<b>JRPP No</b>	<b>2011SYE020</b>
<b>DA No</b>	<b>DA11/0090</b>
<b>Local Government Area</b>	<b>Sutherland Shire</b>
<b>Proposed Development</b>	<b>Demolition of Existing Structures; Construction of a Residential Flat Building Consisting of 70 Apartments over Basement Parking; and 70 Lot Strata Subdivision</b>
<b>Street Address</b>	<b>273A Fowler Road, Illawong Lot 11 DP 1107327</b>
<b>Applicant/Owner</b>	<b>Mr Peter Azar/Azar Building &amp; Construction Services Pty Ltd &amp; Key Sites Pty Ltd</b>
<b>Number of Submissions</b>	<b>8</b>
<b>Recommendation</b>	<b>Refusal</b>
<b>Report By</b>	<b>Mark Adamson – Manager – West Assessment Team (Planner)</b>

## Assessment Report and Recommendation

**Figure 8 – View along rear boundary of the subject site and adjoining shopping centre loading dock access ramp**

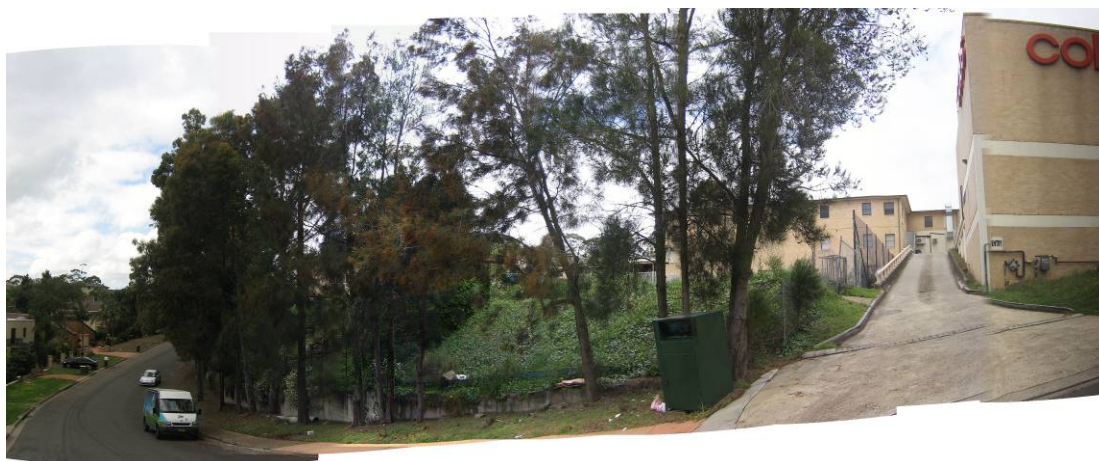
The proposal is non-compliant with the required 4.0m setback to the rear boundary having a nil setback. This boundary of the site abuts the adjoining loading ramp driveway that services the supermarket development on the adjoining shopping centre site. Compliance is not considered essential in this situation as it would be of little benefit either to the proposed development or to a softening of the visual impact from the street. This is due to the western orientation of the site, which will not be beneficial to future residents of the proposed development nor with the outlook towards the blank wall facade of the existing retail building. Views from the street are already screened by existing canopy trees within the public way.
